WASHINGTON STATE
DEPARTMENT OF TRANSPORTATION
CHANGE ORDER

CONTRACT NO: 009015 FEDERAL AID NO:
CONTRACT TITLE: SR 520, MONTLAKE TO LAKE WASHINGTON I/C AND BRIDGE
CHANGE ORDER NO: 77 COVID COMPLETION OF WORK
PRIME CONTRACTOR: SW0211276 GRAHAM CONTRACTING, LTD.
13555 SE 36TH ST SUITE 120
BELLEVUE WA 98006-1442

CHANGE ORDER NO: 77

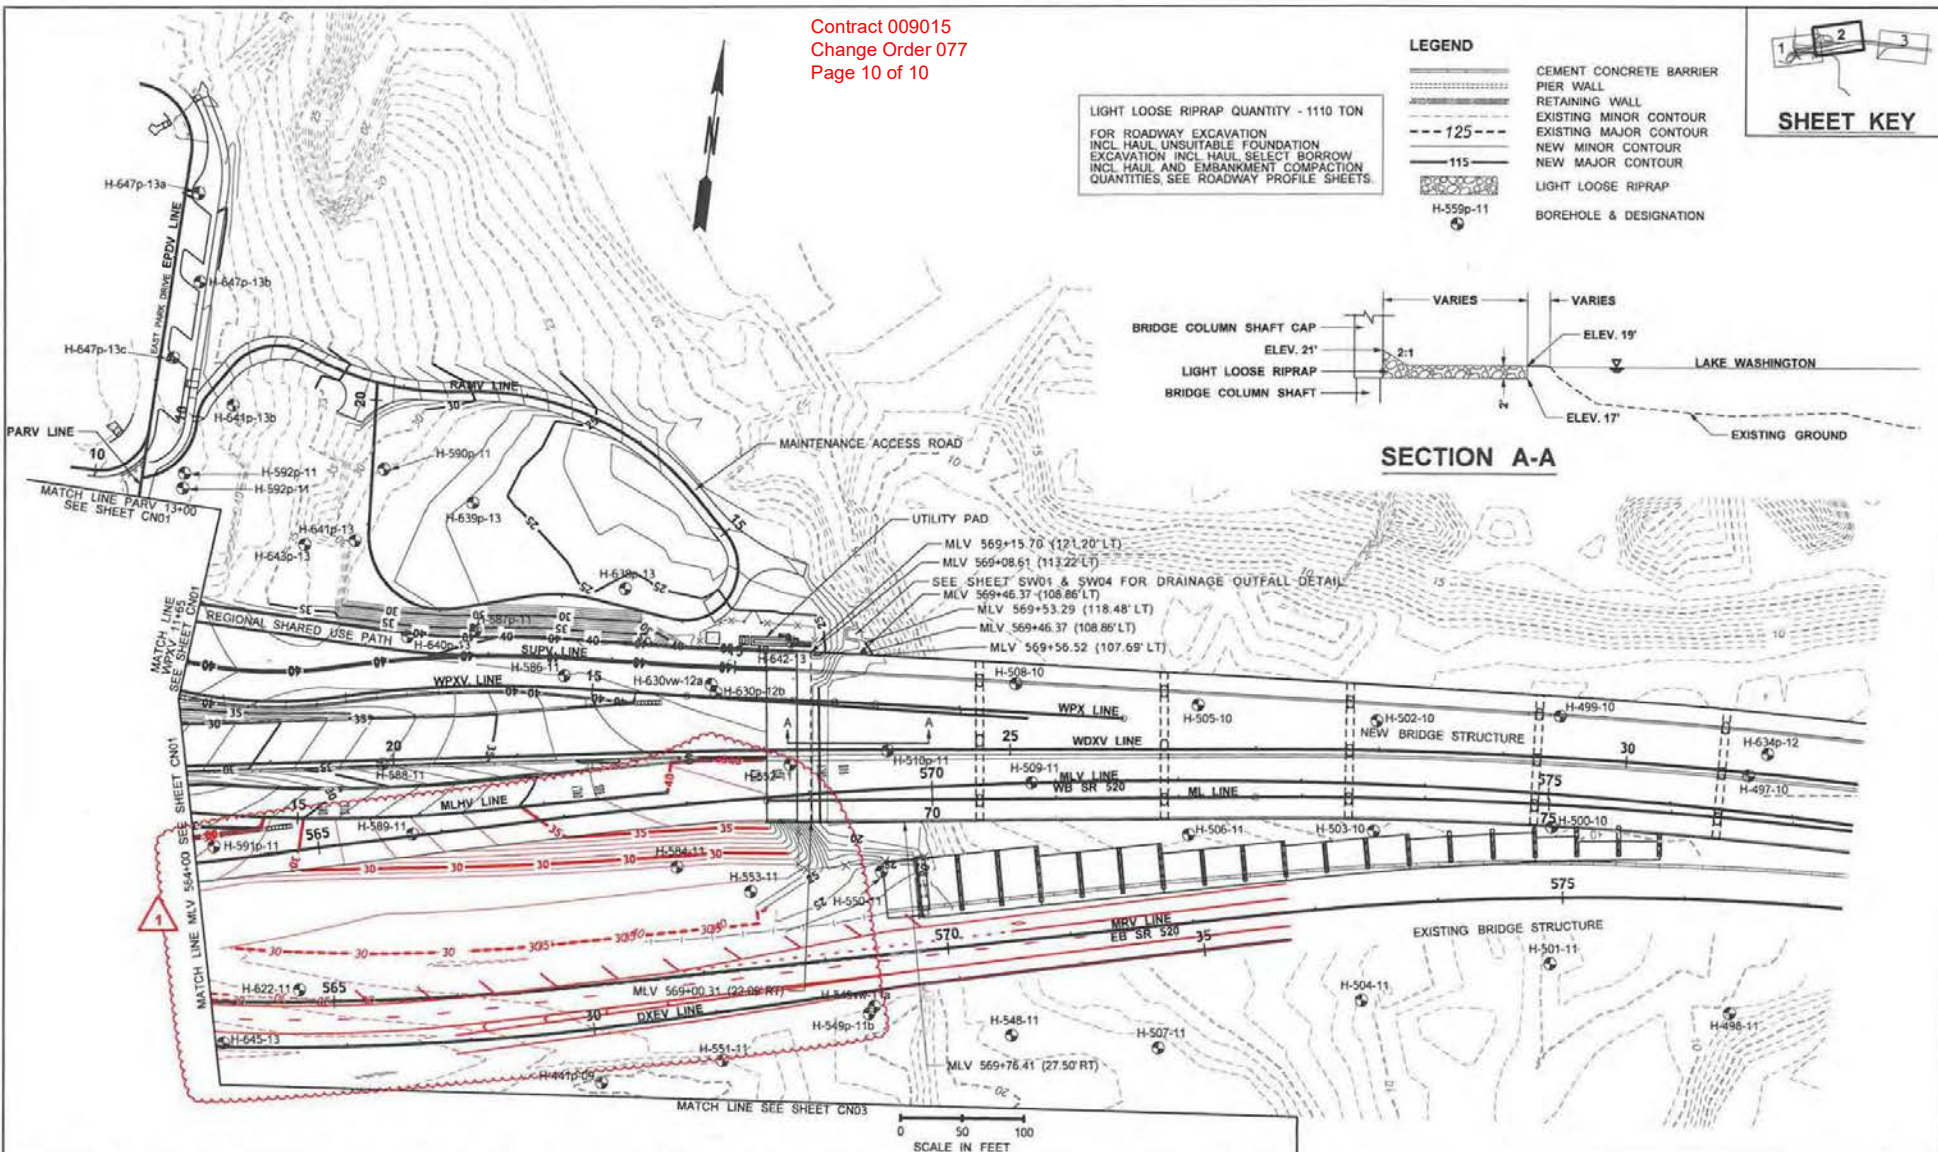
Technical Requirements Section 2.11.5.2 "Abutment Special Excavation and Stabilization" is modified as follows:

Delete in its entirety:

The Design Builder shall excavate the area east of, beneath, and between the WABN and WABS to a depth below the NHMLL as shown in the Shoreline and Abutment Area Excavation cross section on plan sheet RS-07 of the Conceptual Plans (Appendix M1). Excavation shall extend the full length of the West Approach Bridge South (WABS) and West Approach Bridge North (WABN) abutments except that the existing stormwater outfall rock pad shall not be disturbed or destabilized. The Design-Builder shall place 4-inch streambed cobbles, evenly distributed to depth of 6 inches. The average finished surface elevation of the 4-inch streambed cobbles after placement shall be elevation 15.7 feet (project datum). Placement of the 4-inch streambed cobbles shall take place in accordance with Section 2.8 Environmental.

The Design Builder shall place light loose rip rap per plan sheet RS-07 of the Conceptual Plans (Appendix M1), and the Standard Specifications (Appendix B2). Light loose rip rap shall extend the full face width of the WAB abutments."

And replace with:

"2.11.5.2 Abutment Stabilization

The Design-Builder shall stabilize the area east of, and beneath, the WABS and between the WABS and WABN abutments in accordance with the cross-section on Plan Sheet CN02A of Appendix A-B1.E.3 (page 10 of this change order). The new surface treatment shall match the existing surface treatment along the WABN abutment. The existing stormwater outfall rock pad shall not be disturbed or destabilized."
